## ORIGINATION FORM

### Proposed Revisions to a Standard Plans Index

Index Number: 639-001

Index Title: SERVICE POINT DETAILS

DETAIL A  
AERIAL FEED

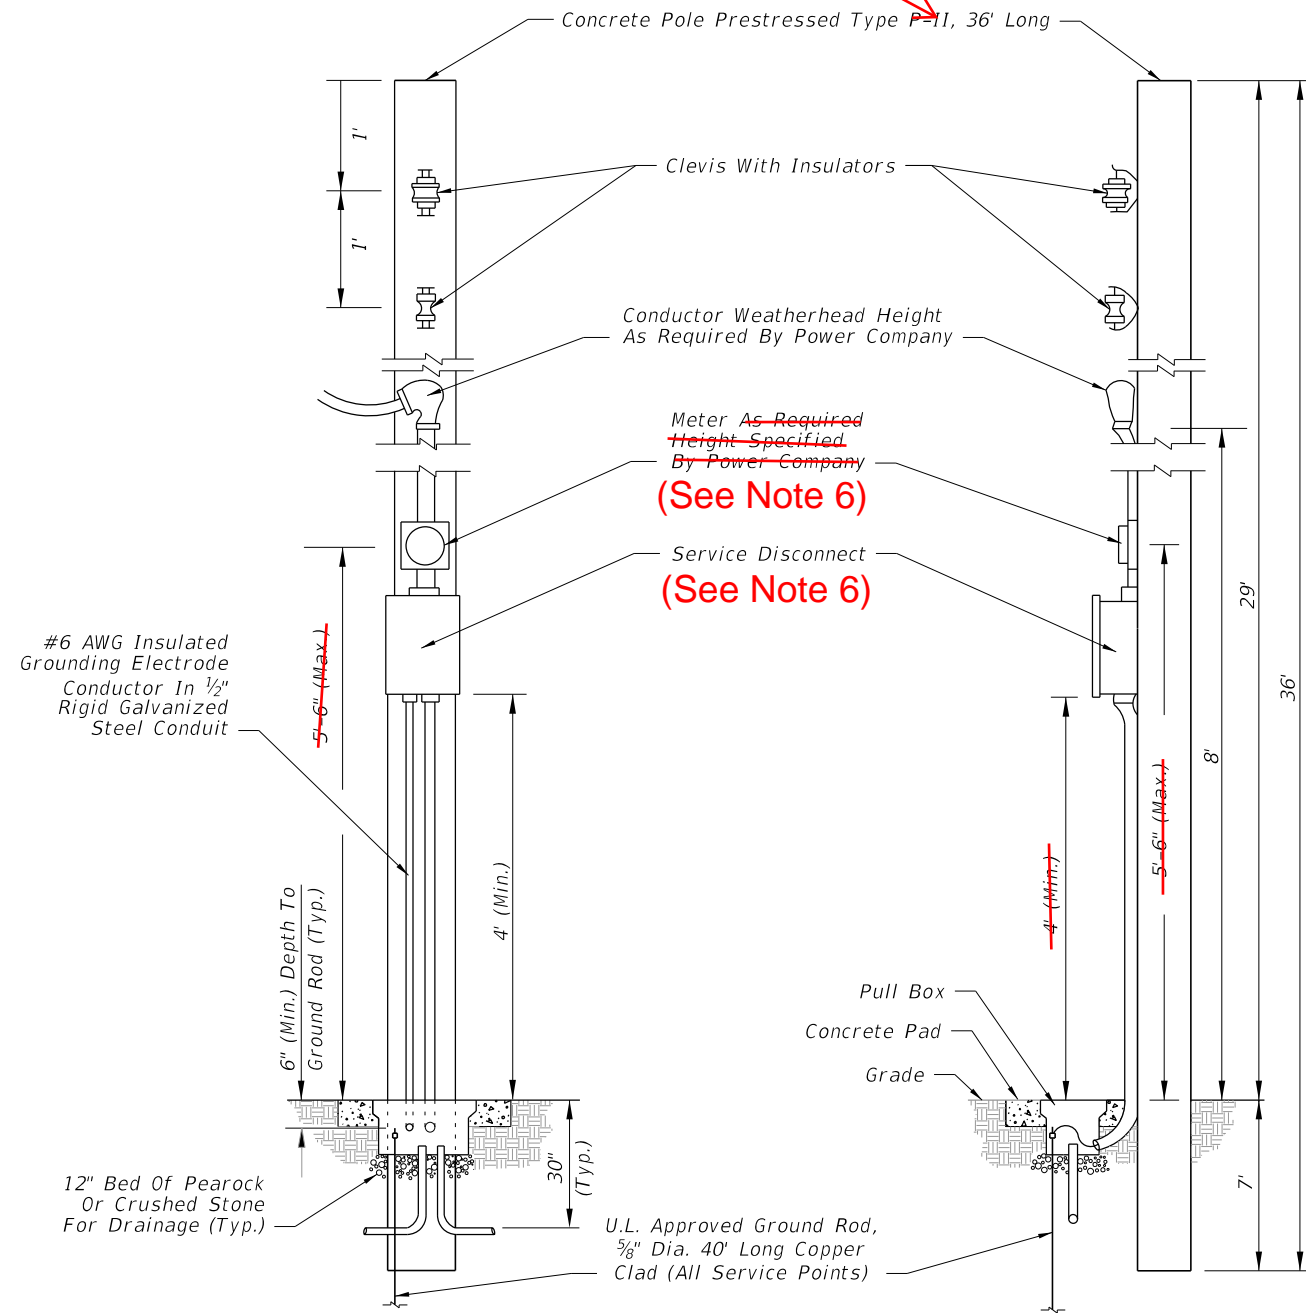
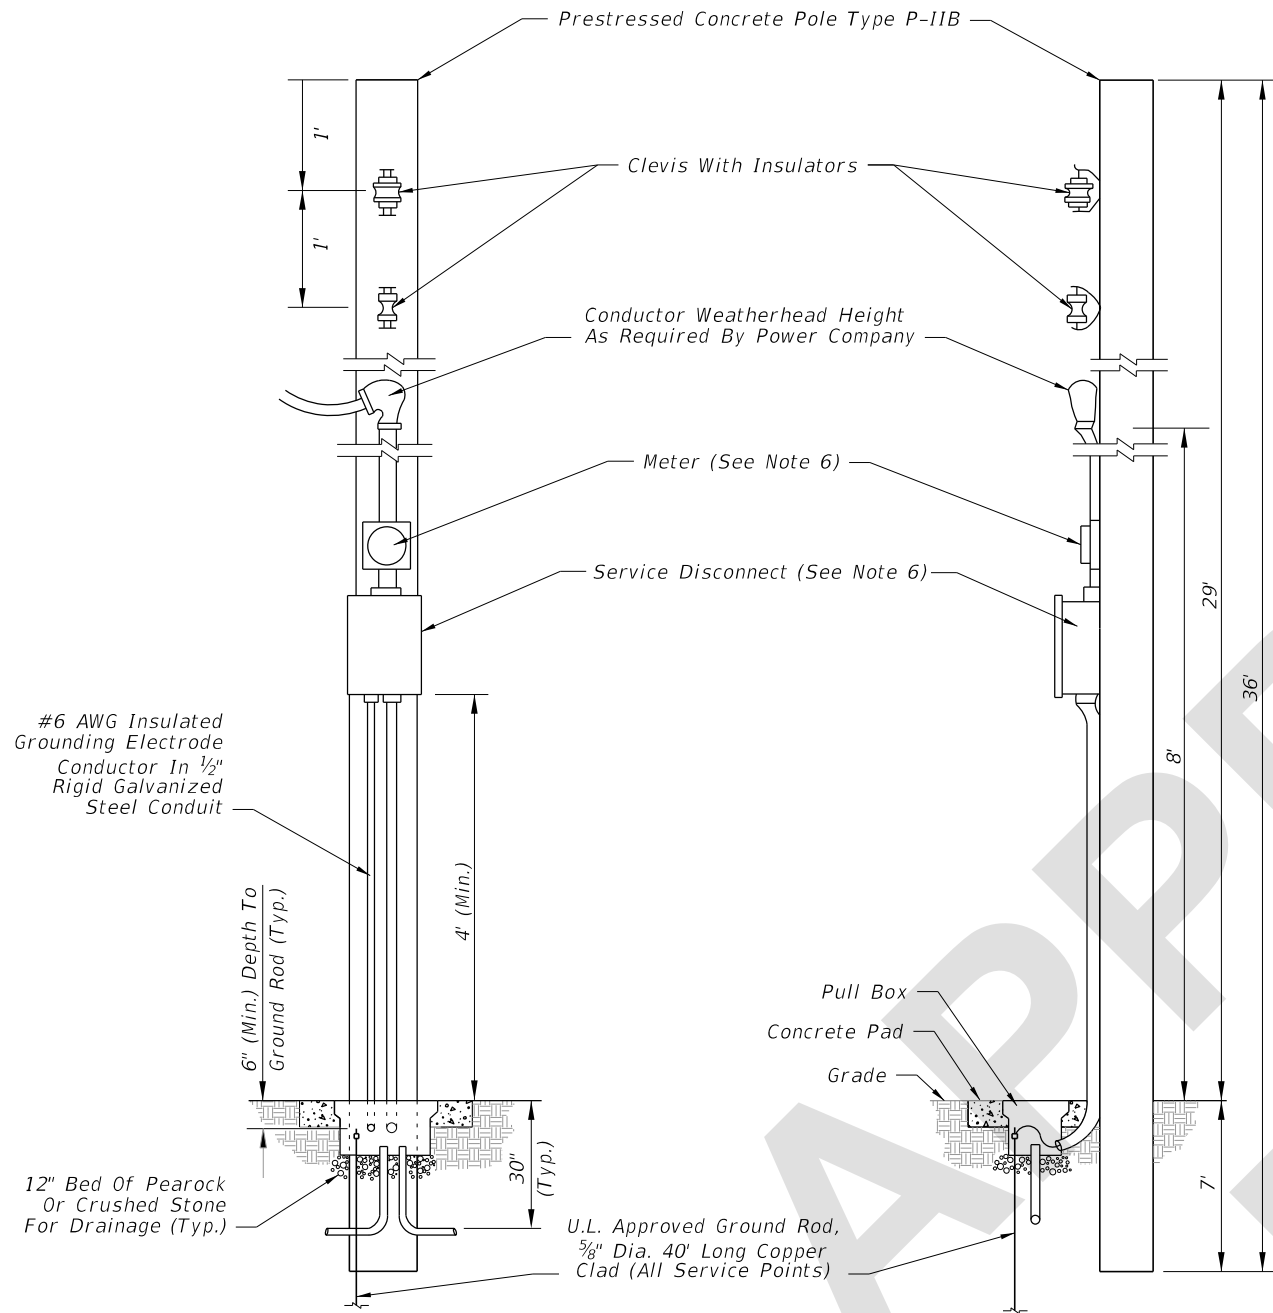
Removed height dimensions for the meter and service disconnect in Details A and B;

Added reference to Note 6 in the meter and service disconnect callouts in Details A and B;

Reworded, added specific "Type P-IIB"

Added note 5 for prestressed concrete pole details and usage

Added note 6 for meter and service disconnect height placement

DETAIL B  
UNDERGROUND FEED

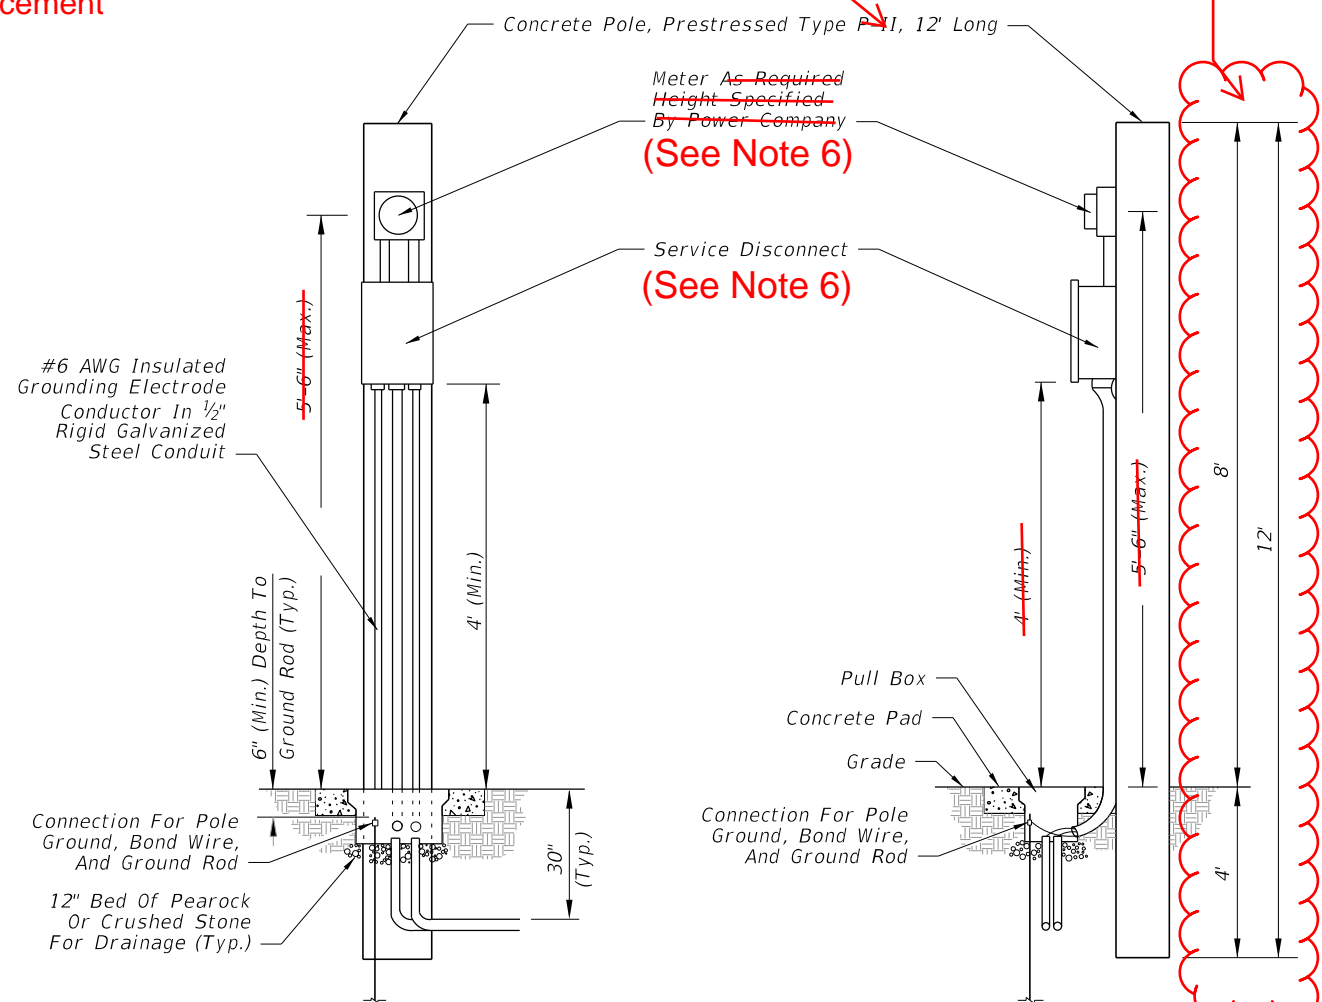
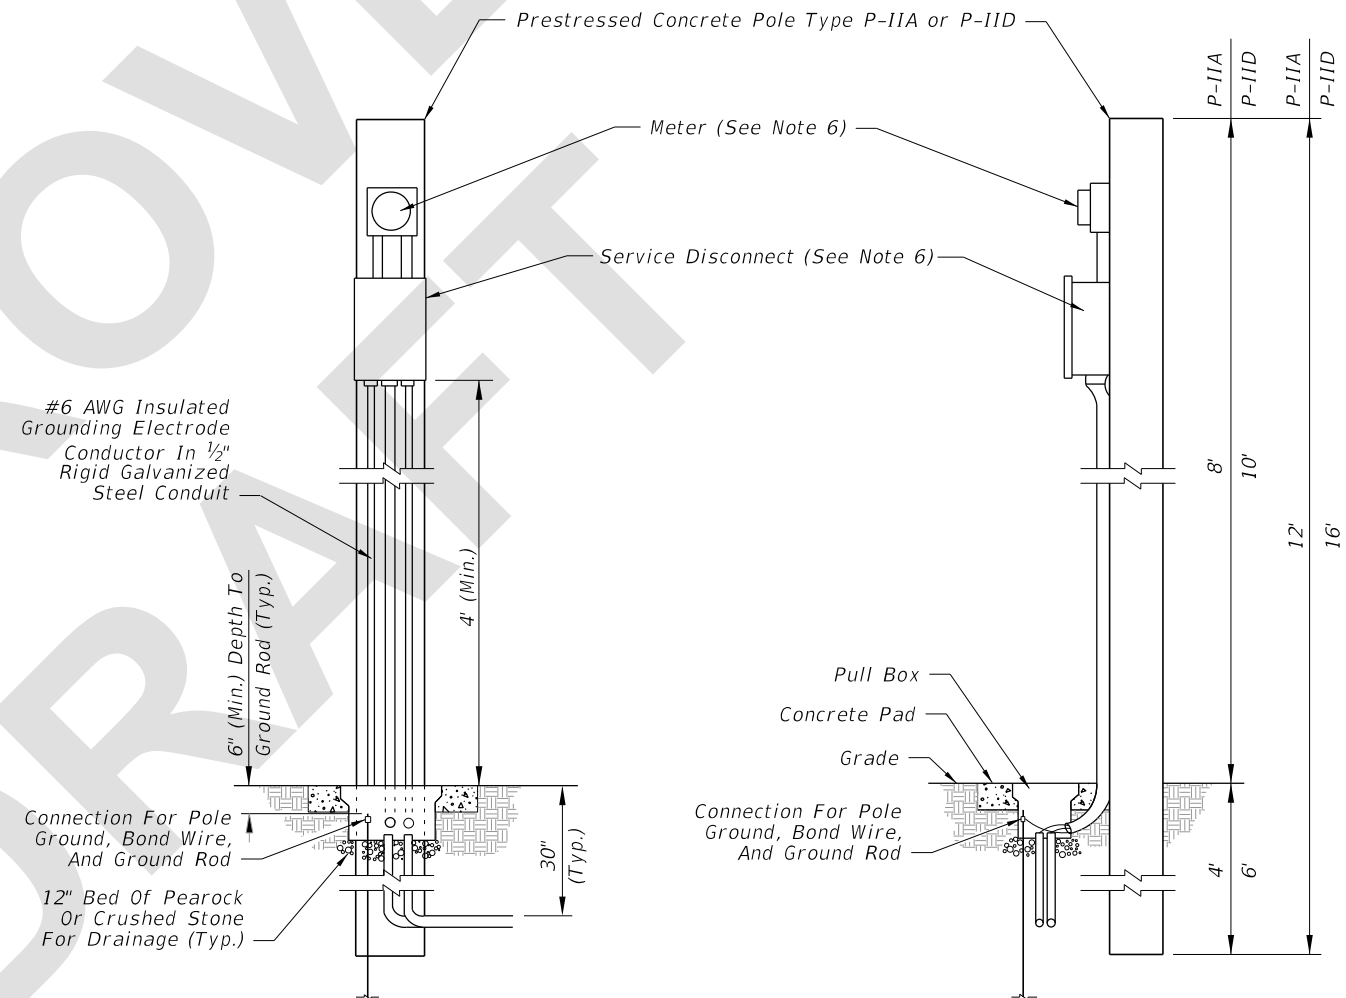
Added pole dimensions for the new Type P-IID concrete pole option in Detail B.

Reworded, added specific "Type P-IIA & P-IID"

Added dimensions for pole types P-IIA & P-IID
